Re: Zircaloy Clad  
Conversion  
ISAP Topic 2.17

Haddam Neck Plant  
Additional Information  
Small-Break Loss of Coolant Accident Analysis--  
Zircaloy Clad Fuel

Attachment  
Haddam Neck Plant  
Additional Information

FIGURE 8-1

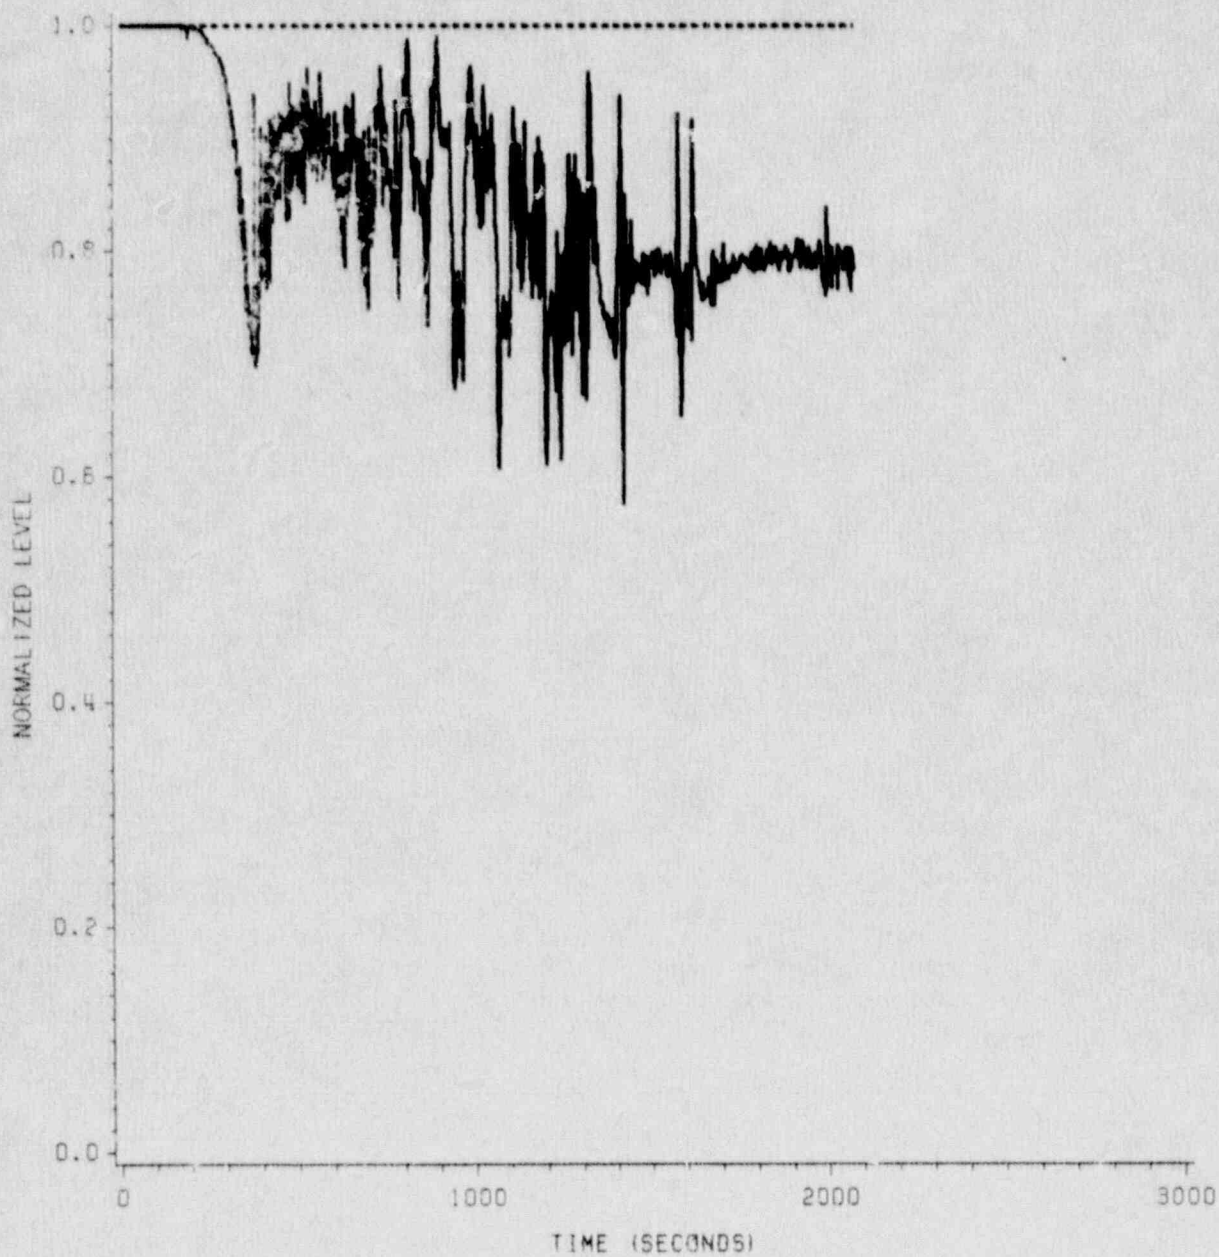
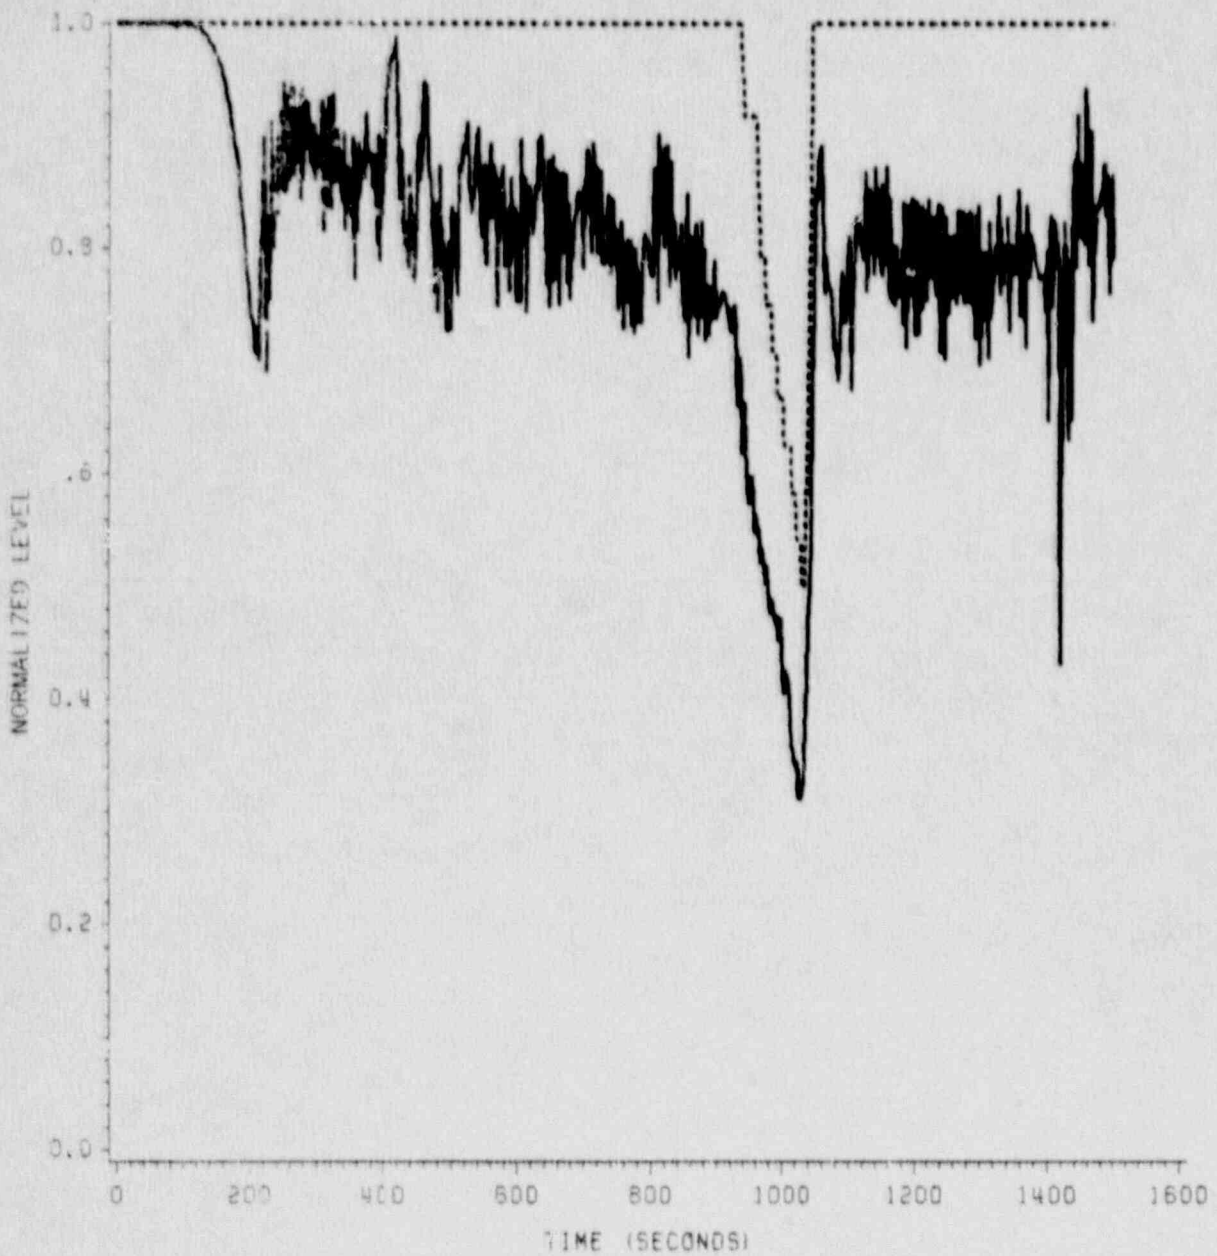
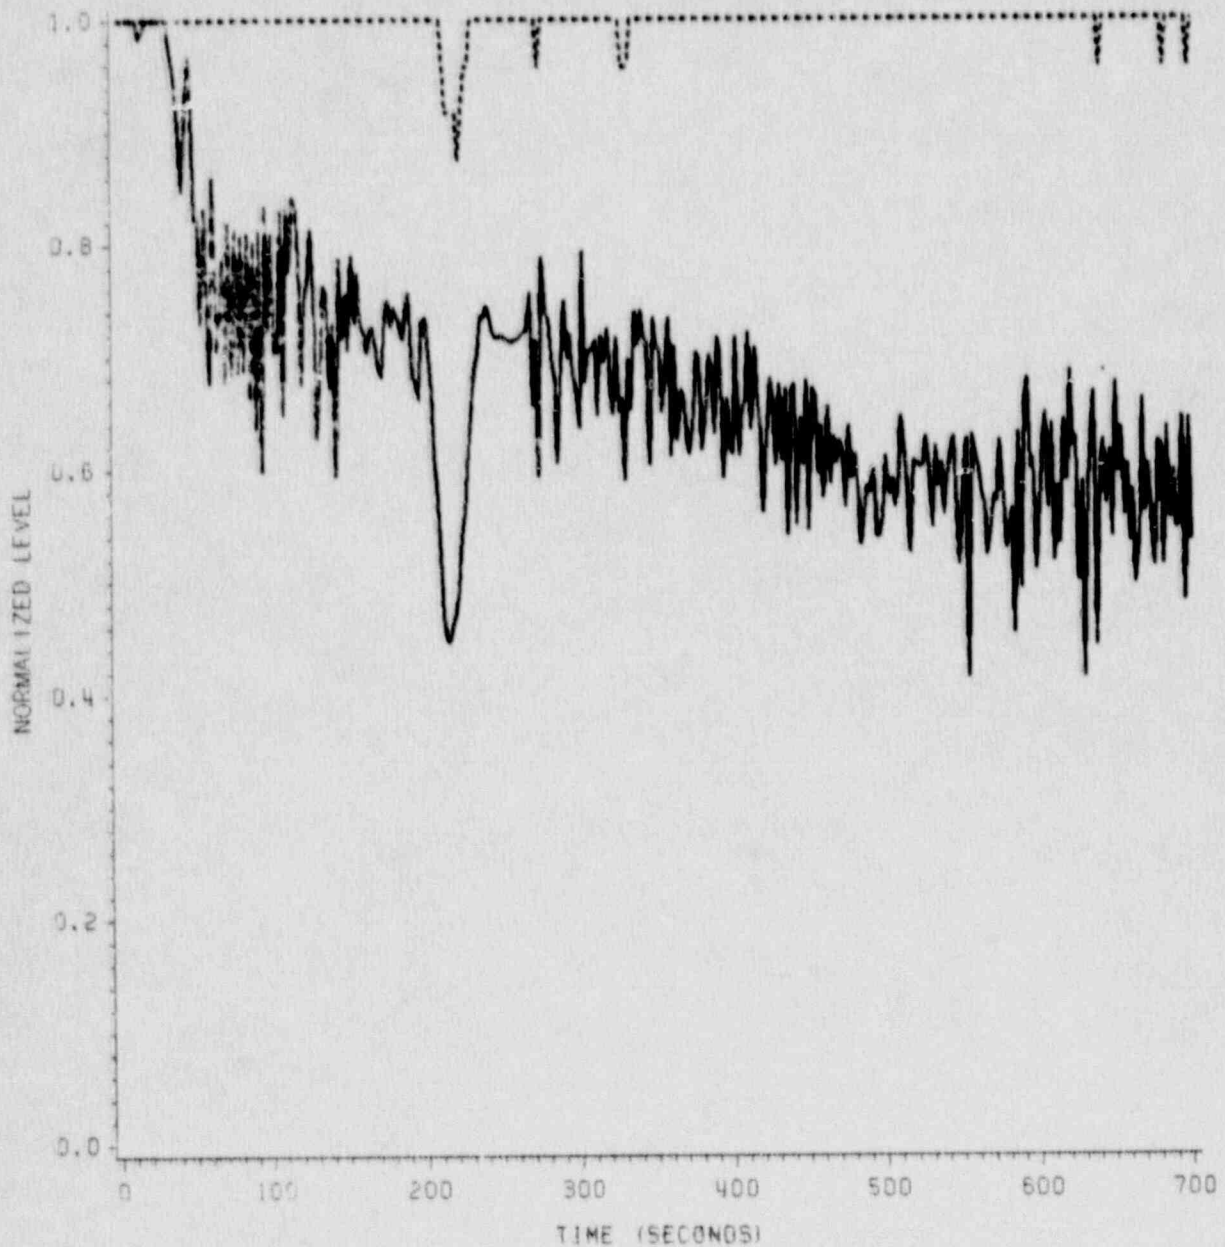
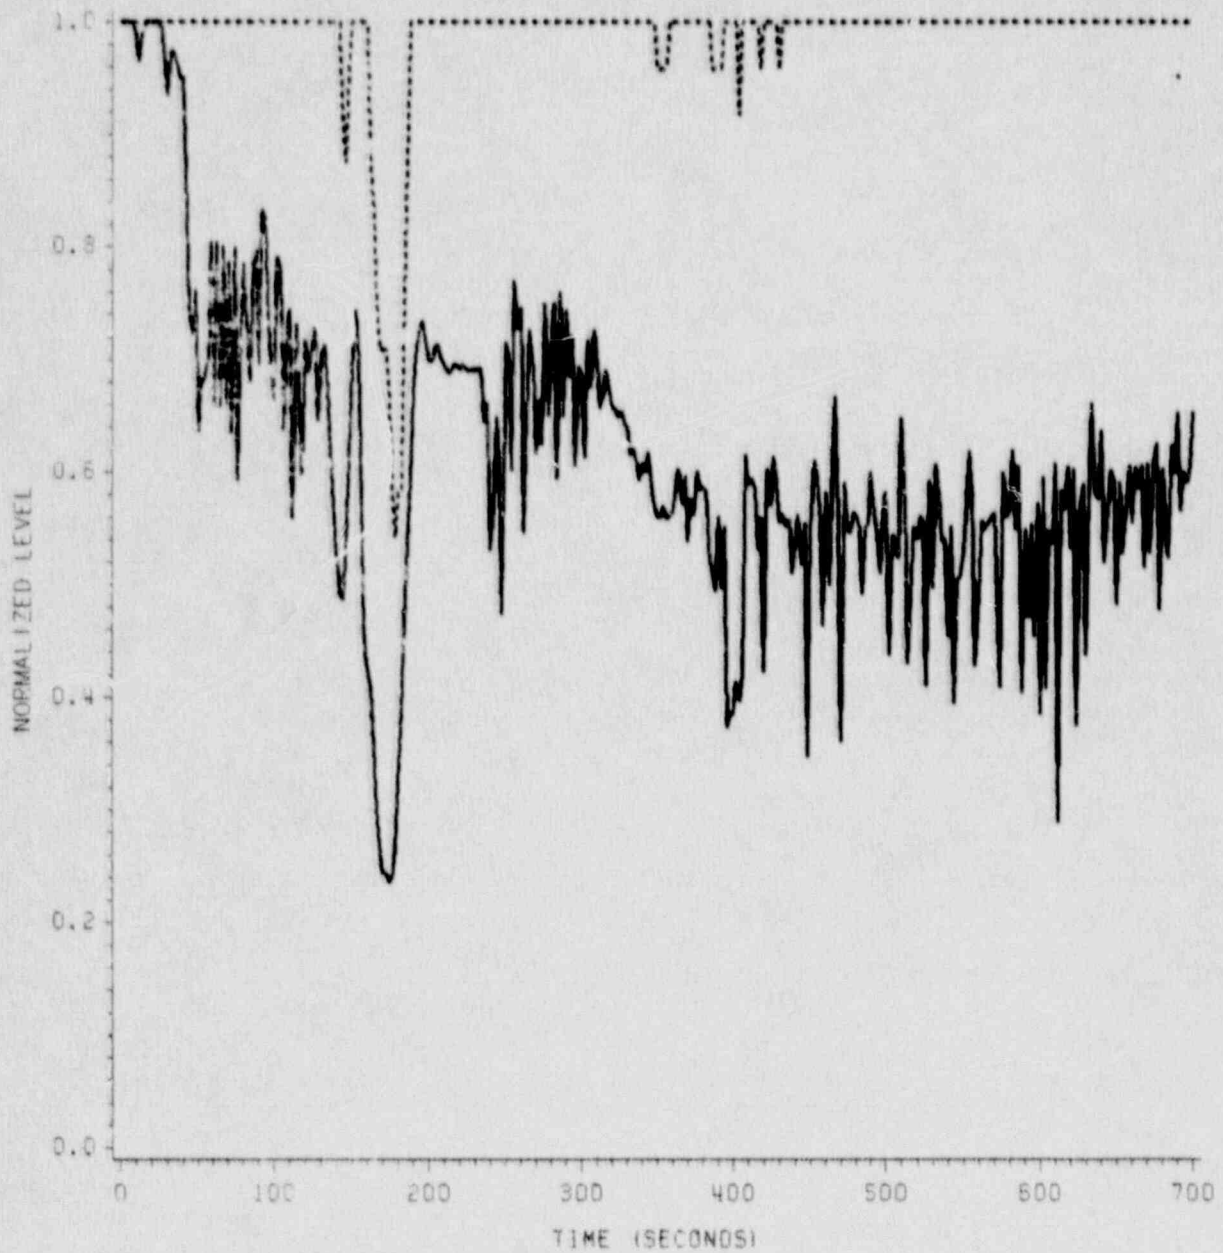
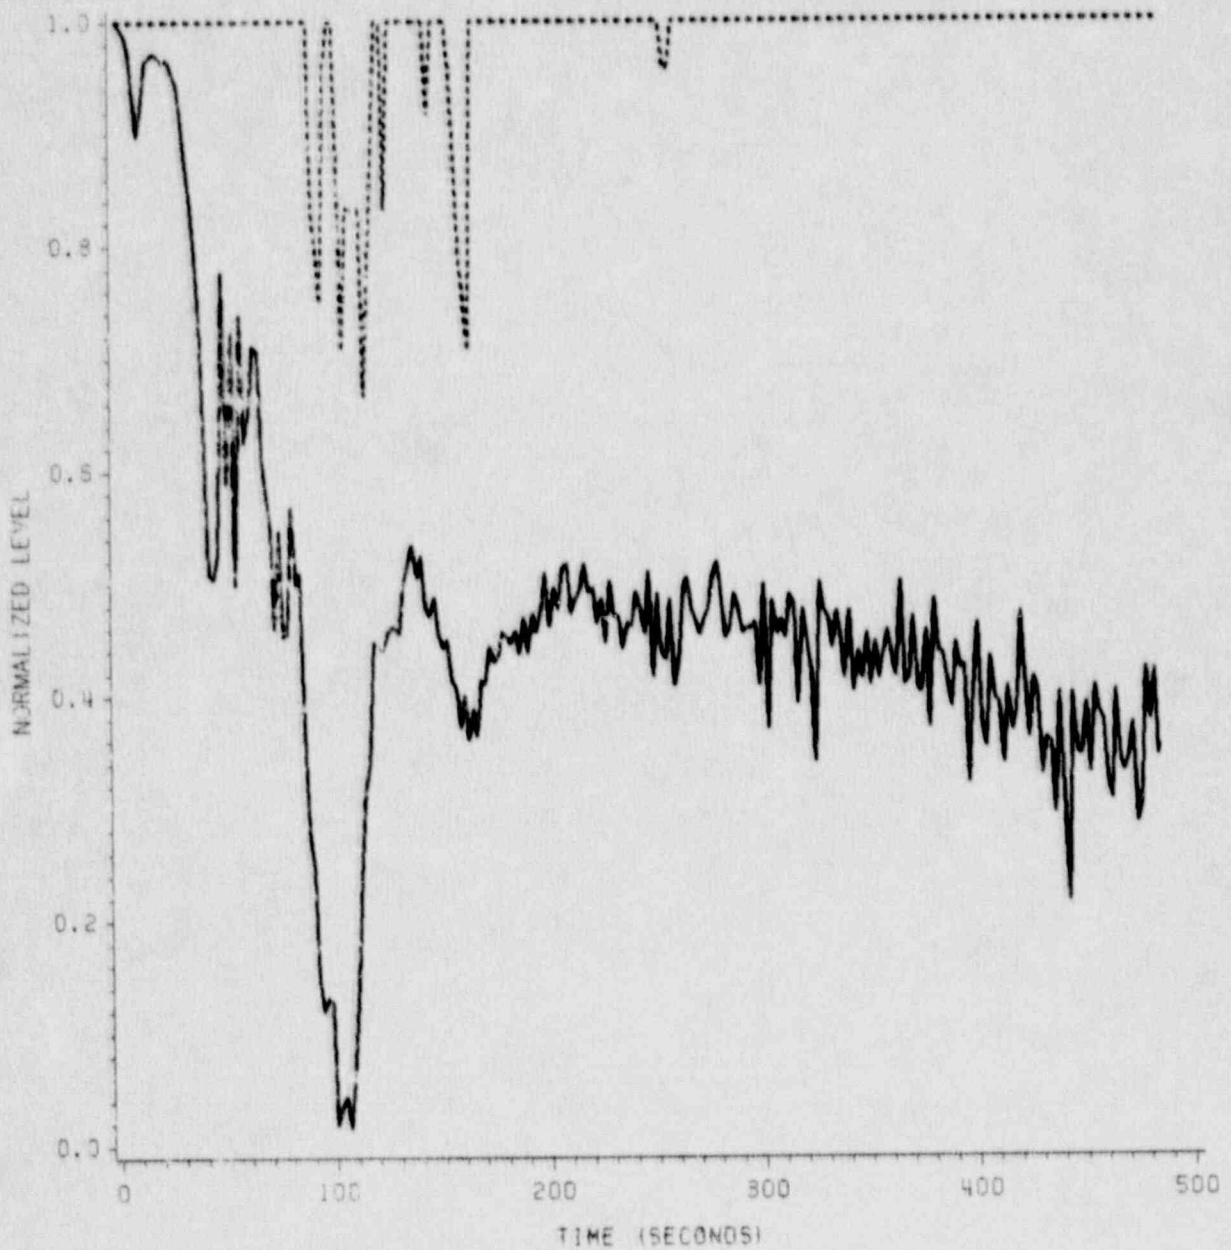
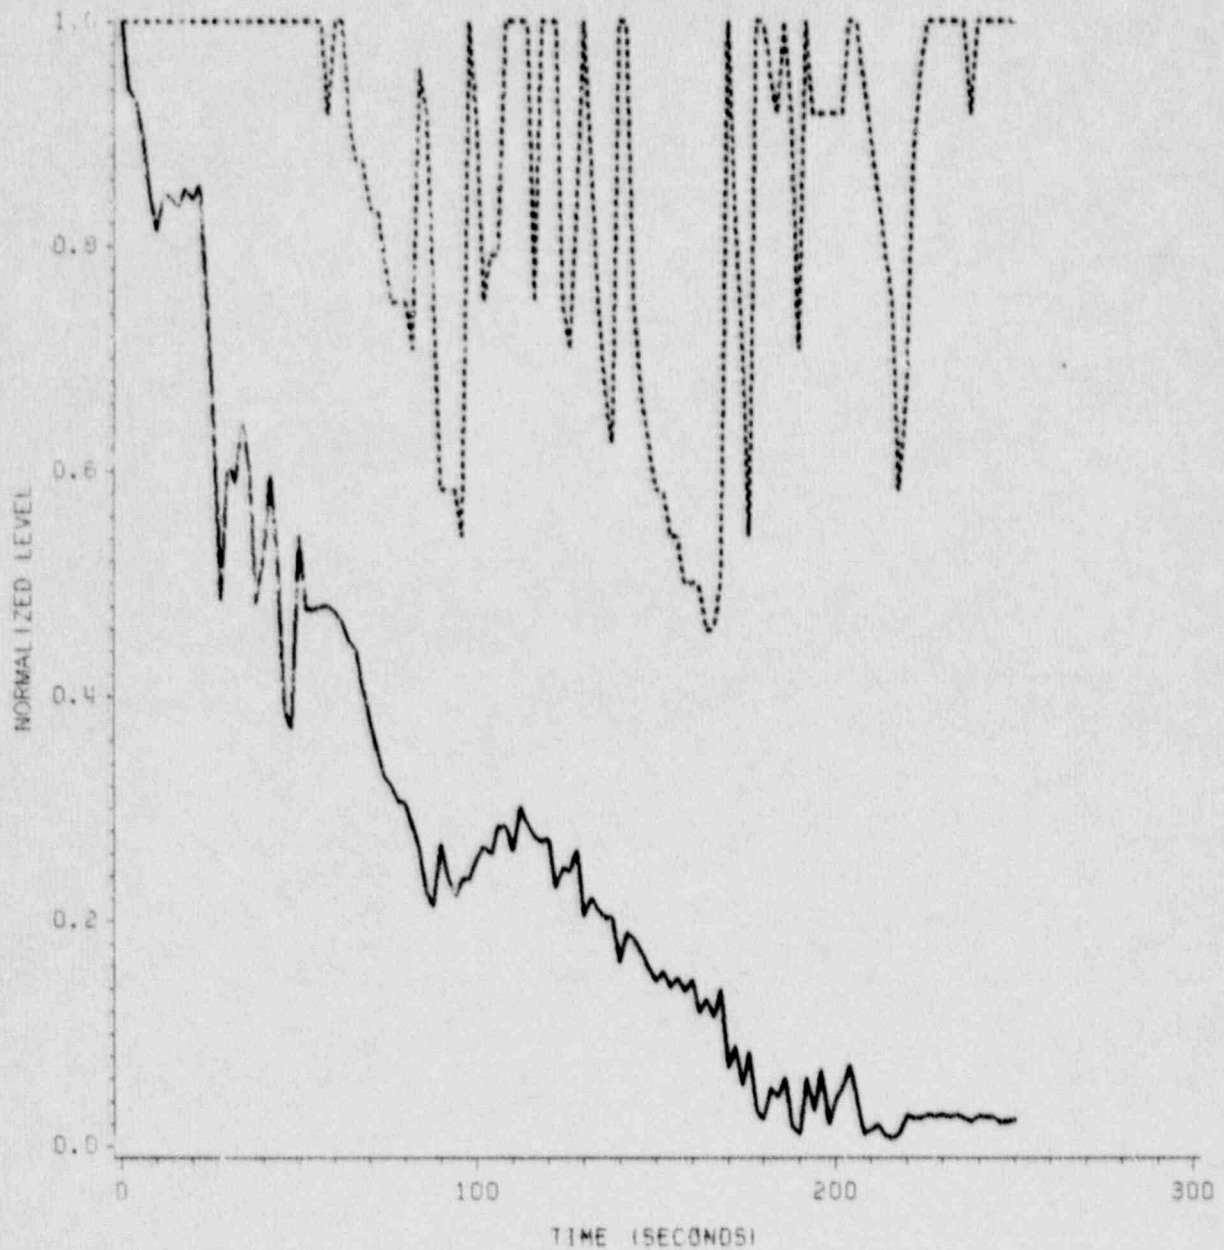
With regard to Figures A.15 through F.15, define two-phase level and discuss its use as part of your evaluation methodology. We have also noticed a possible inconsistency in the relation between the two-phase level and the collapsed liquid level. Specifically, in Figure E.15, an initial depression of the two-phase level occurs when the collapsed liquid level shows a significant increase. Also in Figure F.15 at the end of the transient, the two-phase level is about 90% and the liquid mass is less than 5%, while earlier, at about 90 seconds, the liquid mass is about 25% with a corresponding two-phase level of about 55%. Please explain in detail the relation between the two-phase level and collapsed water level indicated in this Figure as well as Figures A thru F.15.

For the zircaloy clad fuel analyses, the two-phase level provided on Figures A.15 through F.15 is defined as the normalized elevation within the active fuel region of a volume node just below the first node exhibiting a void fraction of 1.0. Since NULAP5 neither explicitly calculates a two-phase level nor uses it in any calculation, this definition was chosen arbitrarily to facilitate the determination and plotting of two-phase level. The two-phase level was provided for information only.

The inconsistency in the relation between the two-phase level and collapsed level is due to an error in plotting the two-phase level. The two-phase level plots shown on Figures A.15 through F.15 are actually the two-phase levels for the 121 outer assemblies core channel. The collapsed levels are correctly plotted. Figures 8-1 through 8-6 provide the correct curves for collapsed and two-phase level for the 36 center assemblies. It is easily seen that the correlation between two levels is improved.

We agree that there appears to be an inconsistency between collapsed and two-phase water level toward the end of the transient for the 0.4 ft<sup>2</sup> break (Figures F.15 and 8-6). This particular break is relatively large and exhibits some of the phenomena associated with medium to large break LOCA's. During the rapid blowdown, there was insufficient time for a well defined two-phase level to develop. Within the NULAP5 Code there is no direct relation between the collapsed and two-phase levels. Both are calculated based on the void fraction distribution in the core channels. As discussed above, the determination of two-phase level is somewhat subjective and can lead to confusing results when applied to highly transient conditions as is the case for the 0.4 ft<sup>2</sup> break. We suspect that for a more stable, quasi-steady conditions that would occur during a long term uncover/recovery period, the consistency between collapsed and two-phase level would be significantly better. Since no long term uncover was predicted due to the large capacity of the ECCS, this effect could not be shown.

It should be noted that for the 0.4 ft<sup>2</sup> break, the data beyond approximately 140 seconds is not representative of the actual plant response since RCS pressure is below 300 ps and LPSI would have injected. LPSI was not modeled for this small break spectrum.
